INSTRUCTION TO SERVICE

ITS60429		May 26, 2022
SECTION:	284-ELECTRICAL PANELS (SC, RP)	
WRITTEN BY:	Filipe Matias	
SUBJECT:	Install ultracapacitor delay relay	
ISSUE:	Ring gear damage causing stalling and inhibiting the bus from starting (Only for SR-2276)	
SUMMARY:	Ring gears are being damaged from excessive torque upon startup. Excessive torque occurs when low voltage batteries are fully charged and ultracap engages upon startup. To remedy this issue, this ITS will add a delay to the ultracap to lower the impulse when battery charge is greater than 24V.

ITS60429

Figure 2– Location and removal of wire 11PS22VB

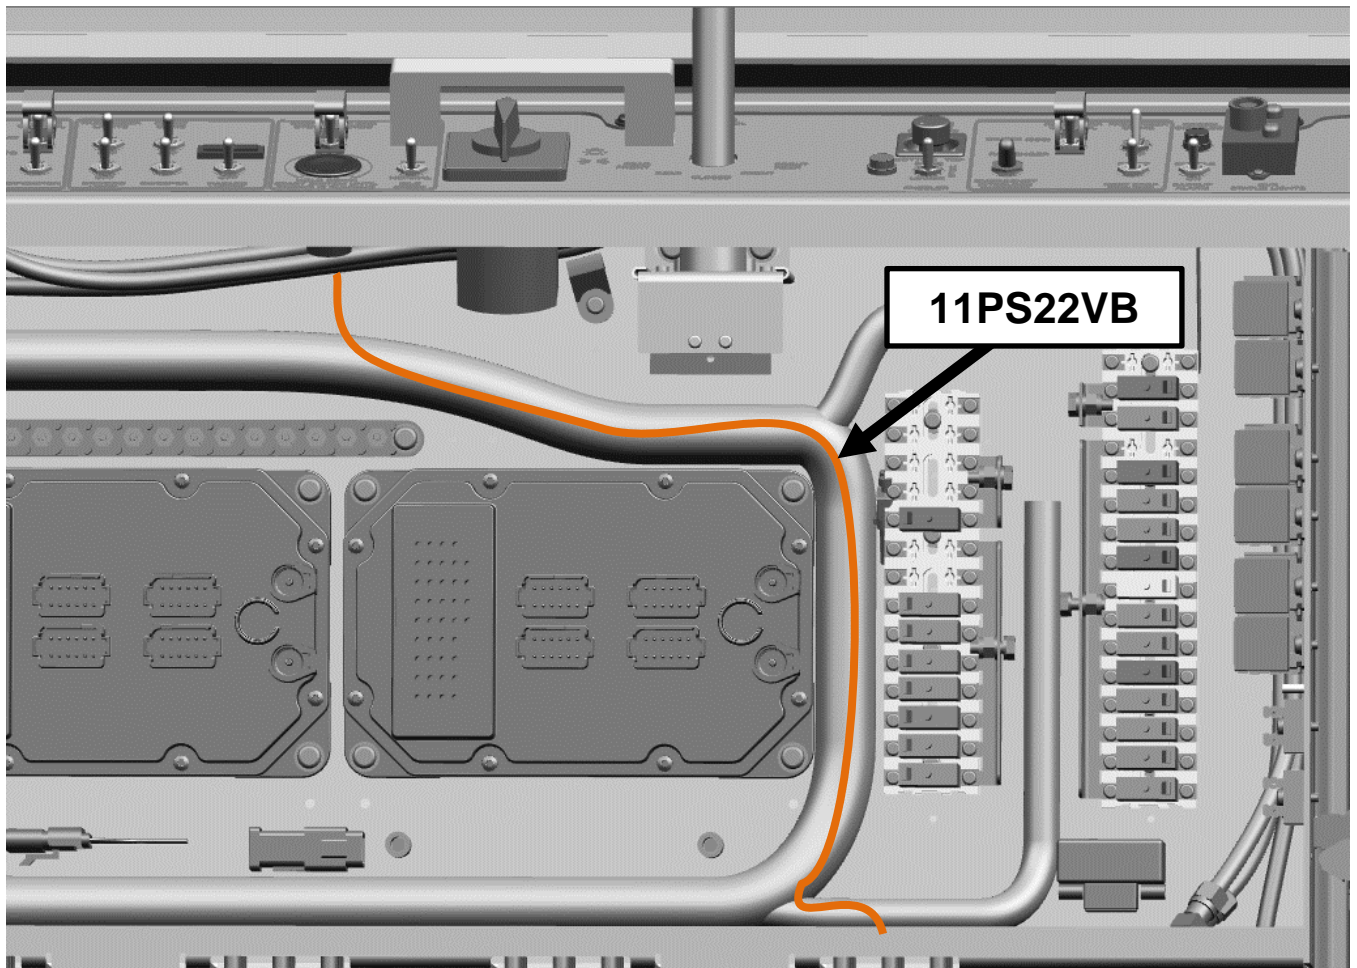
3. Locate the wire 11PS22VB, connected from the Start Push to Start Switch on Term 4 (see Figure 2), to connector XSC68 (Pin C) as shown in Figure 7.
4. De-pin/disconnect both ends of the wire and discard.

Figure 3 – Relay Location

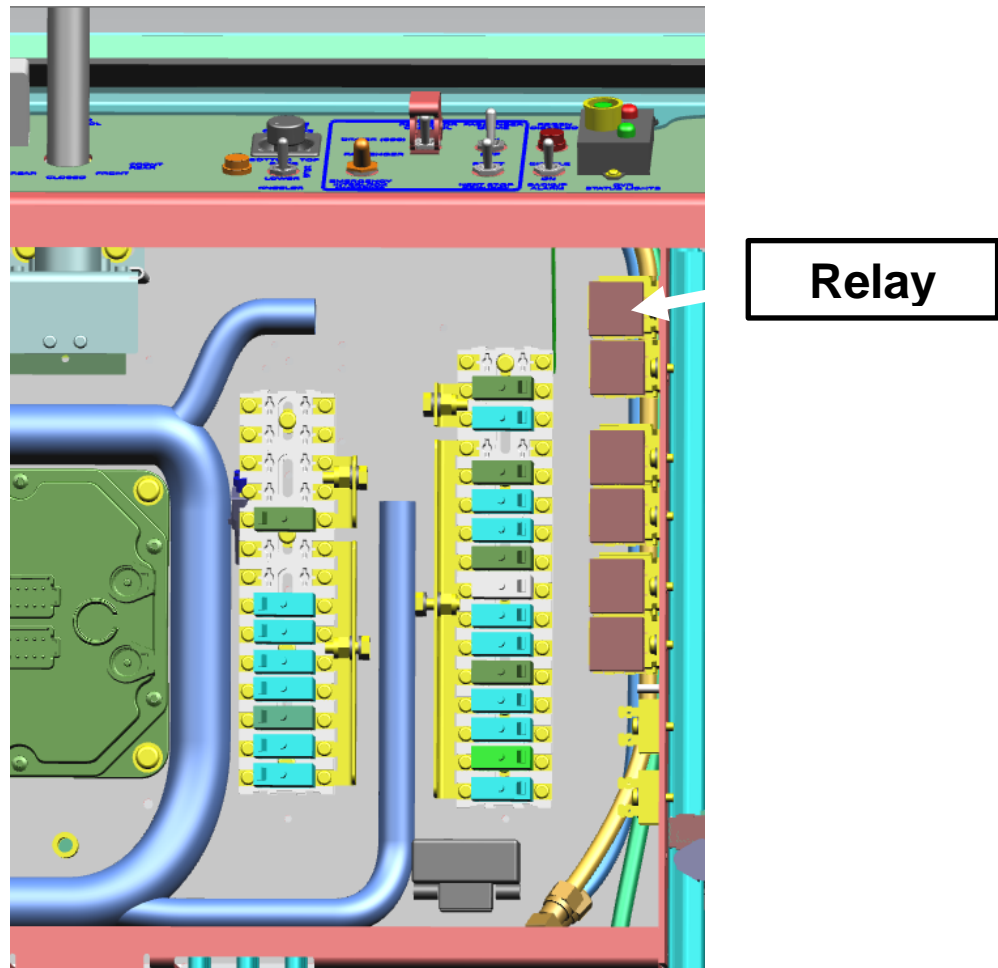
5. Mount the new relay UCAP DELAY RLY on the right side of the Side Console Panel as shown in Figure 3.

- a. Screw P/N: 14S00006  **NOTE:** Torque to 22 IN-LBS (DRY)
- b. Washer P/N: 659000
- c. UCAP DELAY RLY P/N: 106614
- d. Base – Locking Relay Socket P/N: 685168
- e. Lock – Relay Base P/N: 685169

Figure 4 – Relay Installation Detail

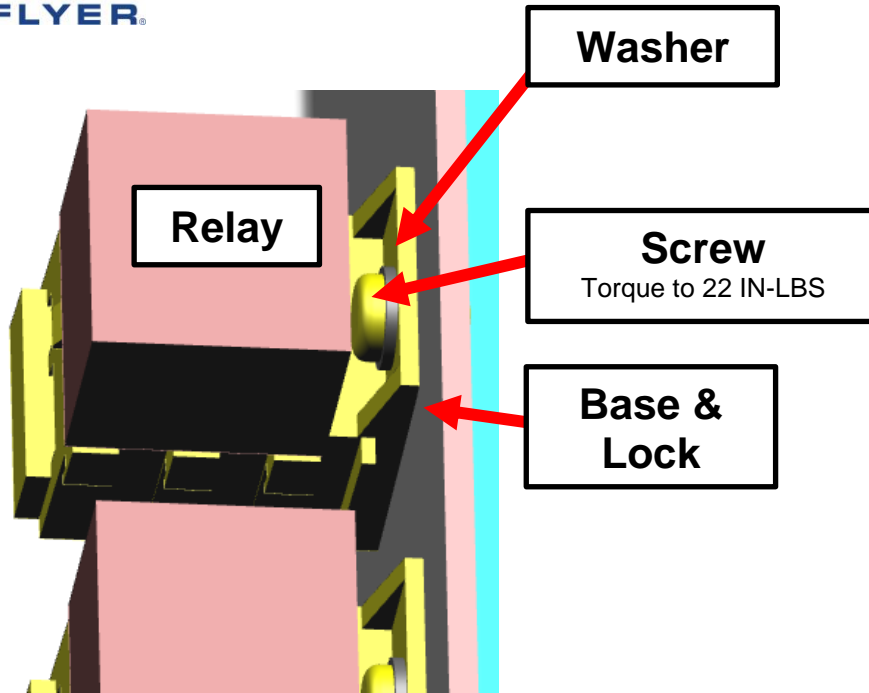
6. Using the supplied harness P/N: 908557, route the wires to the respective locations according to the table 1 below and Figure 4. For further reference, you can also view the schematic in Figure 14.

Figure 7– Connections (Bottom of Side Console)

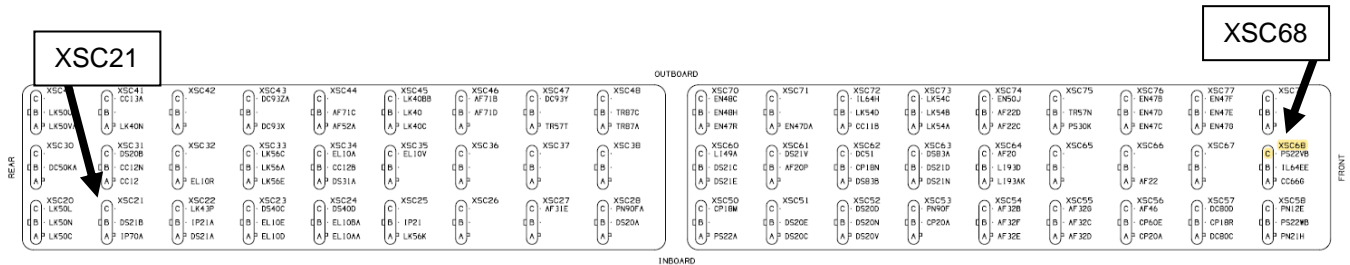
7. Connect the wires:
 - a. 99PS22VB to XSC68, Pin C
 - b. 99PS99AA to Push to Start Button, Term 4
 - c. 99PS99AB to XSC21, Pin C
 - d. 99PS99AC to Ground stud

Figure 9 - Exterior side console view spare harness (Loom removed)

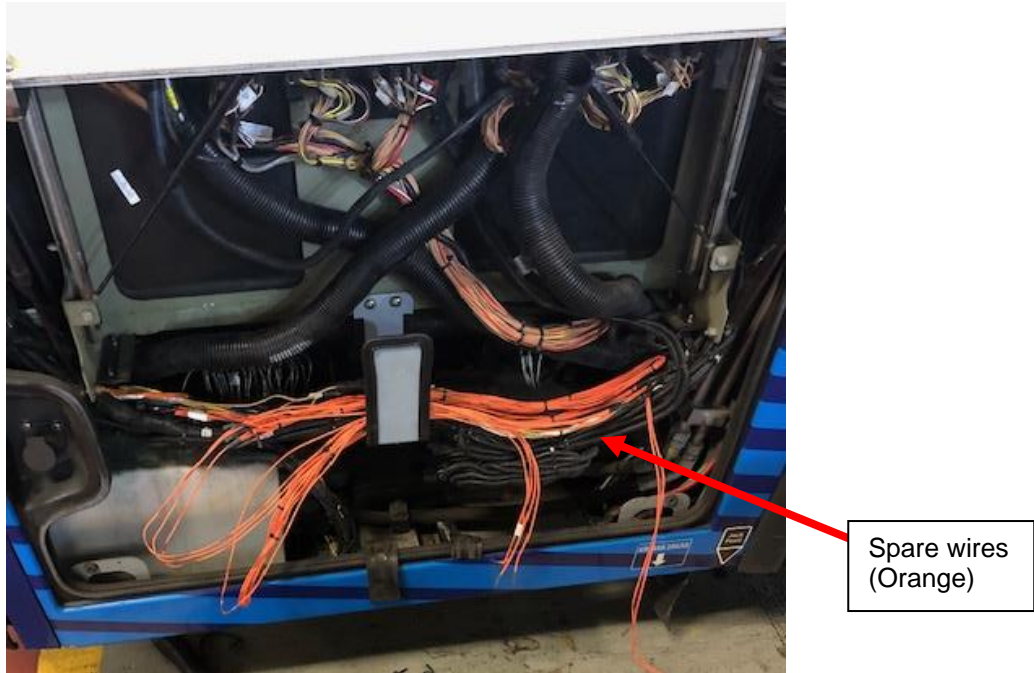
9. Cut the Plastic Ties and remove the Loom as shown in Figure 9.
10. Locate spare wire 53SPR53E 14OR. Strip the insulation from the end of the wire and crimp terminal P/N: 102879; connect to Connector XSC21, pin C.

Figure 13 – Node 14 (J3-6 detail)

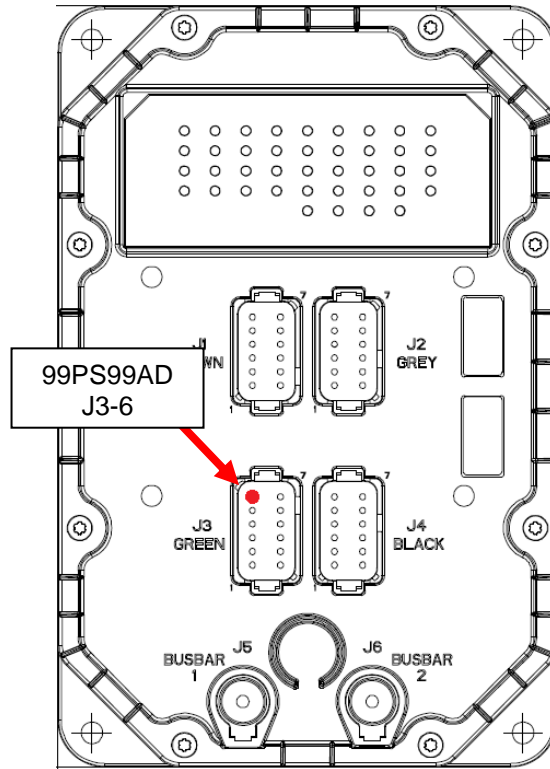
11. Install the Loom over the harness and secure using plastic ties P/N 5958112, 5955945 or 351161, according to the bundle diameter.
12. Gain access to the Rear Panel
13. Locate Spare wire 53SPR53E in Harness P/N 728214 (Right Hand Options) inside the Rear Panel.
14. Strip the insulation from the end of the wire and crimp terminal P/N 034793; Insert in connector XRR53_SHR, location 3 as shown in Figure 11& Figure 12.
15. Route wire 99PS99AD from Module Node 14 to connector XRR53_SHR as shown in Figure 11.
16. Insert one end of wire 99PS99AD to connector XRR53_SHR and the other to J3-6 on Node 14 (Figure 13).

Figure 14 – Schematic

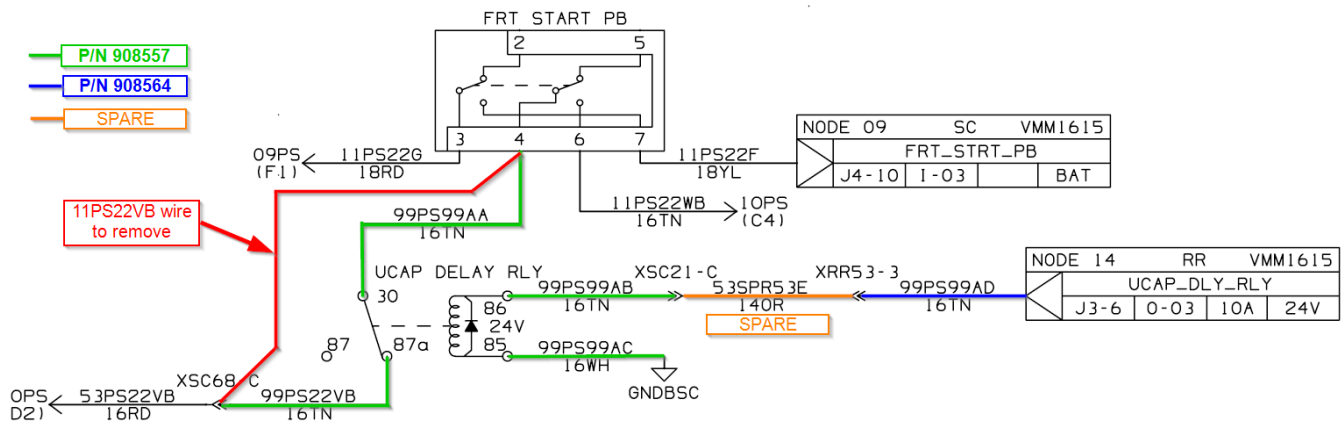
- c. Once the battery voltage is under 24V, check if there is continuity across pins 30 and 87a of ultracap delay relay. See schematic in Figure 14. The relay is normally closed.

- d. Press the front start push button, wait at least 1 second and check continuity across pins 30 and 87a of ultracap delay relay again. There should be no continuity across pins 30 and 87a at this point. If there is continuity, then please contact New Flyer service.
